R34 – 2025

Certificate of Appropriateness for work in the Historic Districts:

**Historical Architectural Review Board
COA Preliminary Review Sheet**

HDC-2025-00003

Elevation at Russell Street (Applicant)

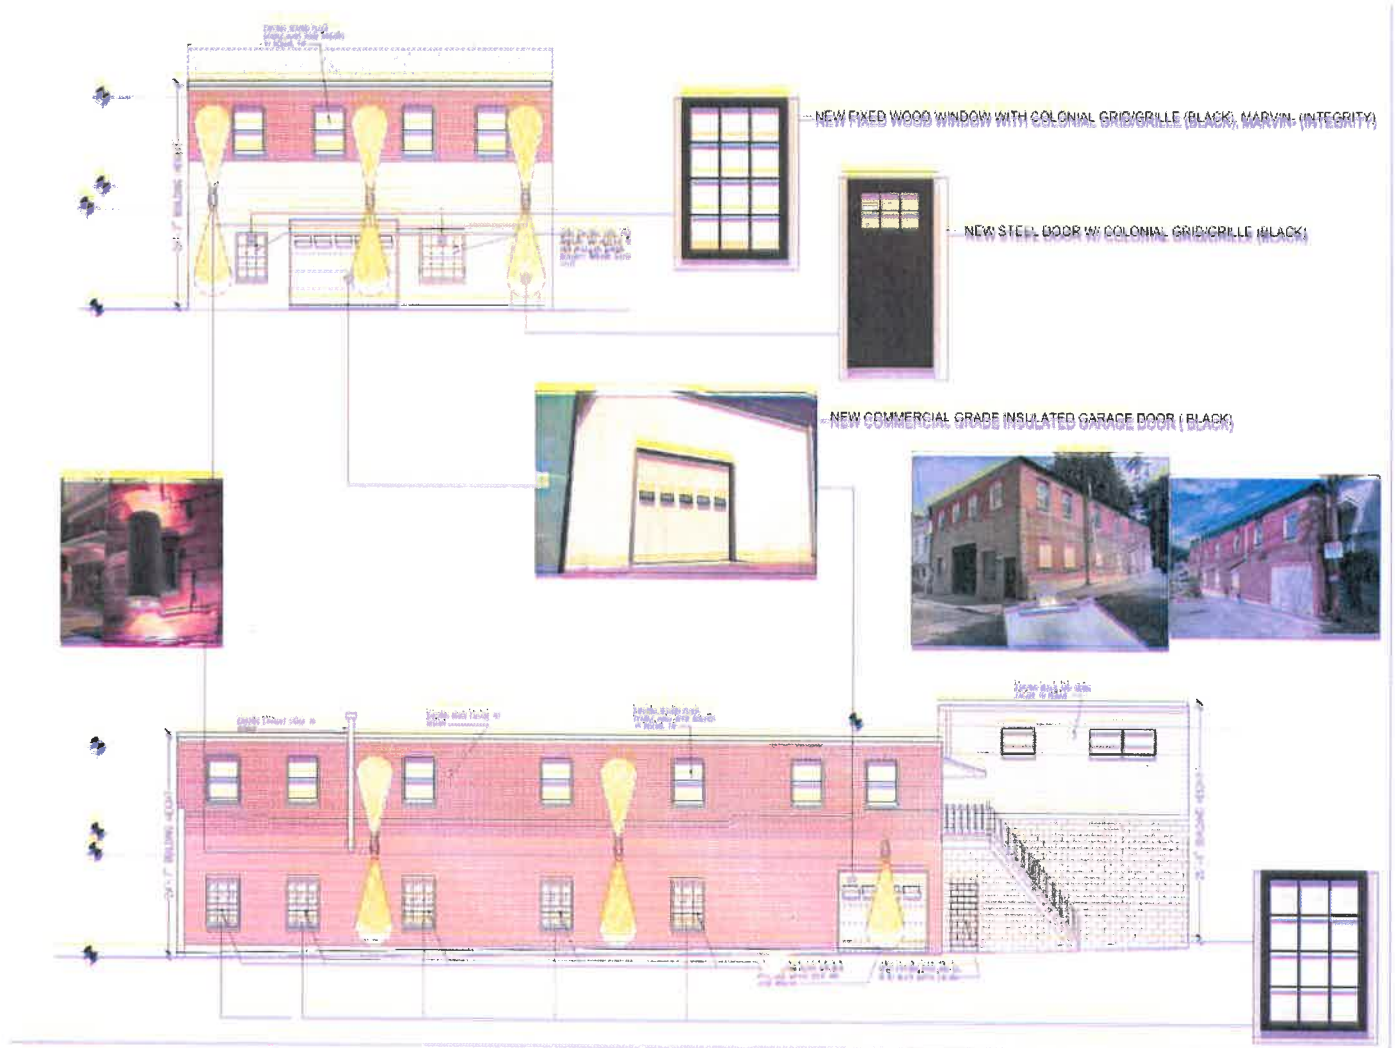
The removal of the CMU block infill at the original windows and garage door locations along Russell Street is appropriate and commendable and helps restore some of the character of the original building.

It would be appropriate for the existing first floor windows on Fountain Street to be repaired instead of replaced, or sufficient evidence should be shared showing that the windows cannot be repaired. While the proposed windows include a muntin pattern consistent with the existing original windows on the first floor, they do not match in materiality and frame dimension. The replacement first floor windows along Russell Street should be steel windows matching the existing first floor windows on Fountain Street in size, type, operation, profile, and appearance.

The style of the proposed garage door is not consistent with the historic district. For the primary garage entry on Fountain Street, a more historically-consistent configuration would be appropriate. There are historic examples of 1930s garage doors that have upper lites, similar to the configuration of the proposed steel entry door. That style garage door paired with the proposed entry door would be a complementary pairing for the front elevation. Other examples of garage doors from that era consist of solid sectional doors with square inset panels, as seen nearby at 926 Oak Street. It would be appropriate for the garage door on Russell Street to be consistent these styles, but given its location on the secondary façade, it would also be appropriate to install a solid sectional door.

- The existing first floor windows on Fountain Street remain and are repaired as required, or evidence submitted that the windows are beyond repair.
- The replacement first floor windows along Russell Street match the existing first floor windows on Fountain Street in material, size, type, operation, profile, and appearance. Replacement window product information is to be approved by staff, and finish color for existing and replacement windows is to be decided by applicant.
- The garage door on Fountain Street is an architectural sectional garage door in a design consistent with the historic period. The garage door on Russell Street may match the one on Fountain Street or be a solid sectional door. Garage door product information to be approved by staff.
- The building lighting is installed as submitted.

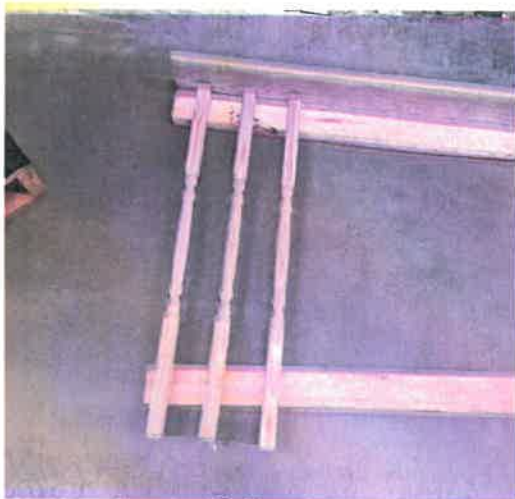
Observations & Comments: The proposed spindles for the railing are an appropriate replacement to the current condition. More information would be helpful to understand the configuration of the proposed railing system, including the orientation of the 2x4 framing shown in the photo "Proposed Railing." It would be appropriate if the construction of the railing maintains similar proportions to the original railing at the front porch, particularly that the framing is oriented horizontally at the top and bottom of the proposed spindles.

The current condition photo indicates additional posts supporting the balcony in addition to two original corner/intermediate posts. More information would be helpful to understand the intent of the proposed work; an appropriate approach would be to repair/replace posts in the original locations and remove intermediate posts that were later added as supplemental support.

All wood elements, including posts, railings, and spindles, are to be painted.

- Railing assembly maintains similar proportions to the original railing at the front porch, and that the railings are constructed in a similar matter (2x framing is oriented horizontally at the top and bottom of the proposed spindles).
- Wood posts are repaired/replaced at the original post locations, and supplemental posts that were previously installed are removed.
- All wood elements are painted.
